## ADDENDUM

NO. 1

**PROJECT NAME:** Lehman High School 2025 Additions and Renovations

**CLIENT NAME:** Hays CISD

**WALL SECTIONS - AREAS A, B**

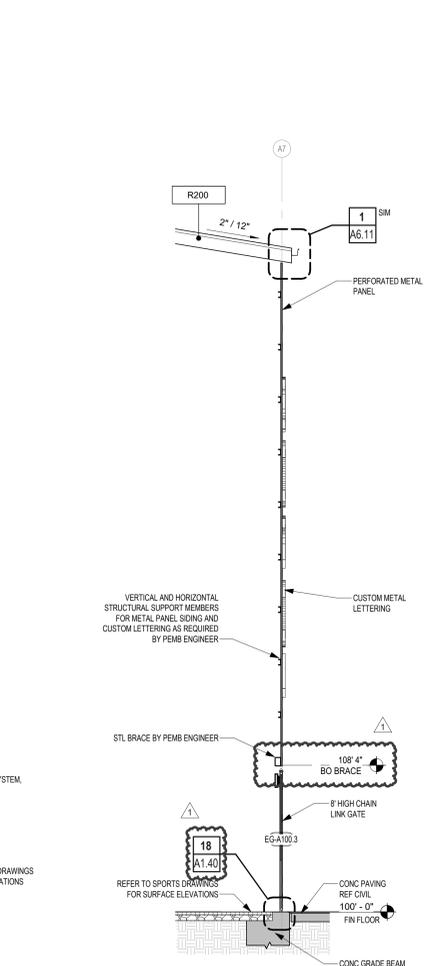
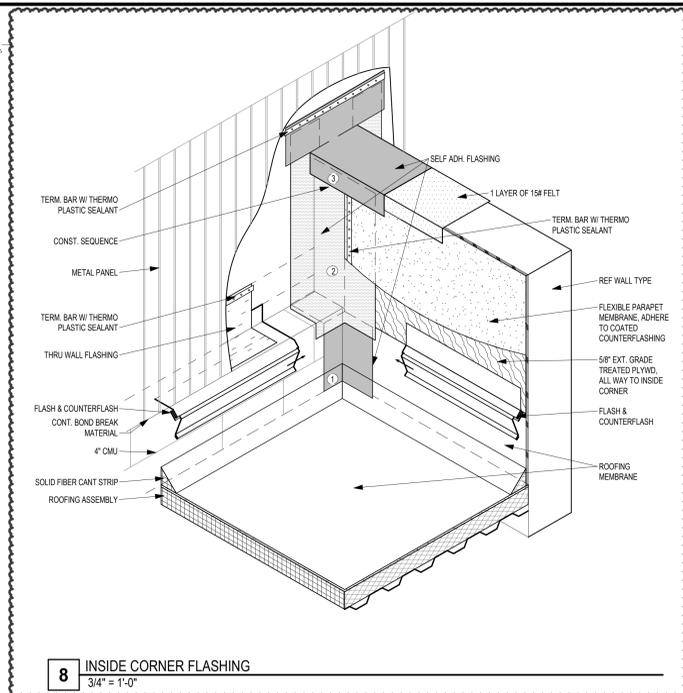
AD. No 1, Arch. Item 23 **To the Drawings, Sheet A6.05, “WALL SECTIONS – AREAS A, B,”**

- 1) Refer to attached drawings 1, 2, 3 to show updated fence locations
- 2) Refer to attached drawing 1 for clarification on bottom of steel brace height

PACKAGE	VOLUME
Job No. 01954-08-01	Sheet No. ISSUE FOR BID
Drawn By: PP	Date: 04/22/2025
<b>ES1.00</b>

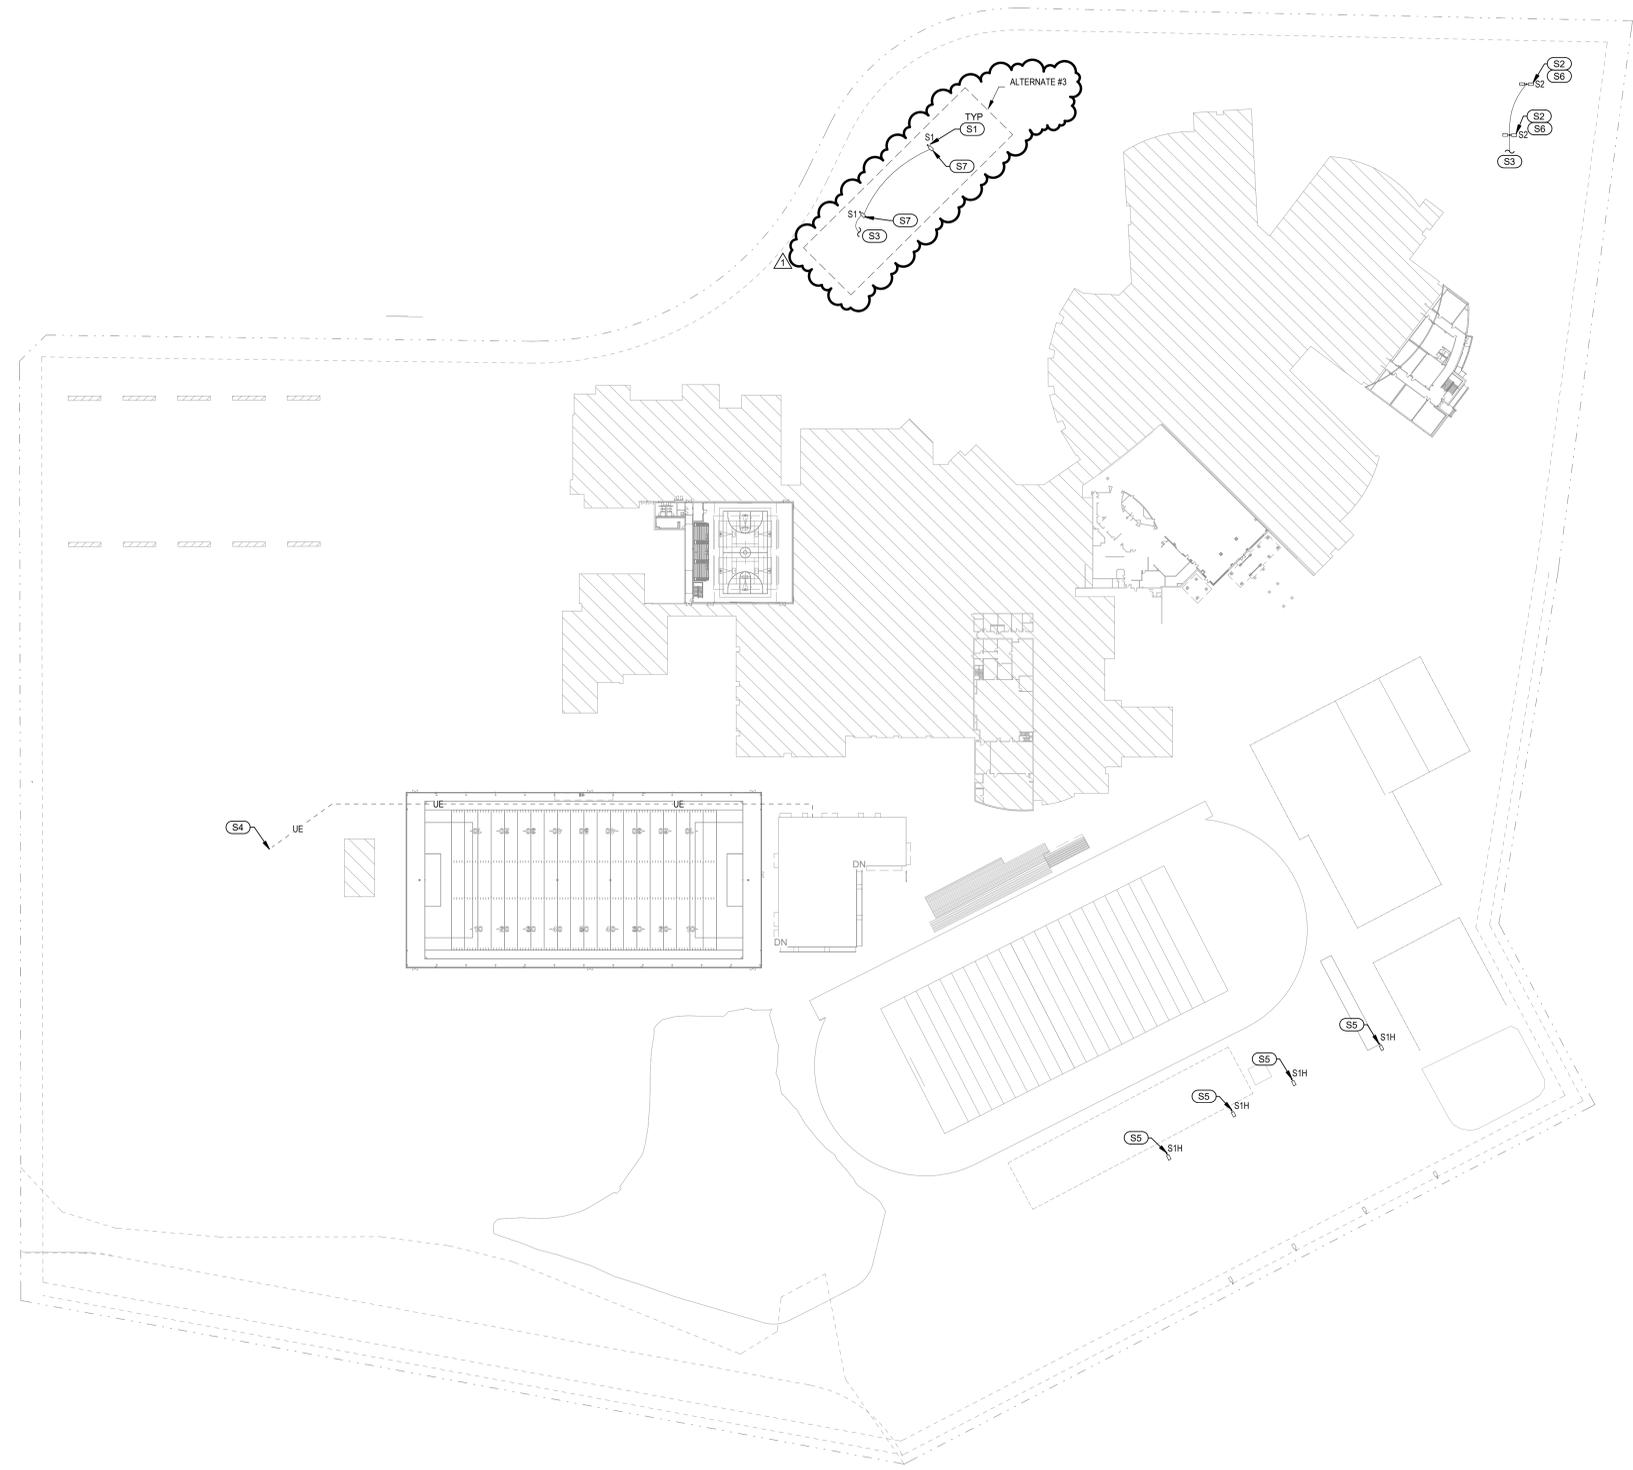
AD No 1, Elec Item 4: **To the Drawings, Sheet ES1.00, "SITE PLAN - ELECTRICAL,"**

- 1) Added notation on front parking alternate as shown.
